IN THE MATTER a submission by KiwiRail Holdings Limited (submitter S442 and further submitter FS236) (**KiwiRail**) on Te Tai o Poutini Plan ("**Plan**")

**MINUTE 59 - MEMORANDUM OF COUNSEL ON BEHALF OF
KIWIRAIL HOLDINGS LIMITED**

Supplementary statement of evidence of Catherine Lynda Heppelthwaite for KiwiRail Holdings Limited

Removal of Overlay on Hokitika Line

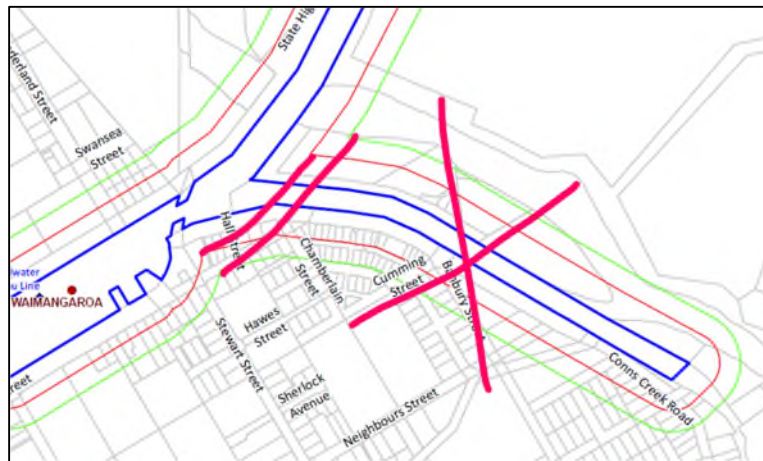
- 3.0 Mr Peakall has raised concerns about a limited array of anomalies with the maps provided by KiwiRail which mean additional area is included that should not be part of the overlay. Prior to supplying the mapping layer to Council officers, and with technical mapping support from KiwiRail's geospatial specialist and Team Lead Planning (Ms Grinlinton-Hancock), I made a detailed review of the designation, existing KiwiRail activities and land use (via aerial photograph) relative to draft noise and vibration overlays.
- 3.1 Examples of areas where the noise and vibration lines were adjusted were shared with Ms Evans and Mr Peakall and some are included below for reference (pink crosses reflect areas to be excluded from the overlays and pink lines showing where overlay should be located).

- 3.2 The maps provided to Ms Evans and Mr Peakall were adjusted to "smooth out" areas such as those shown above. The adjustment of the overlays balances the exclusion of areas that are unlikely to generate any significant effects with ensuring adjacent land uses are provided with sufficient protection.
- 3.3 Dr Chiles' evidence sets out that the 100 metre noise and 60 metre vibration overlays have been set by KiwiRail as a policy decision and that both noise and vibration can extend beyond these distances respectively.⁵ Put another way, regardless of where the limits are set, there will always be variability in effects experienced.
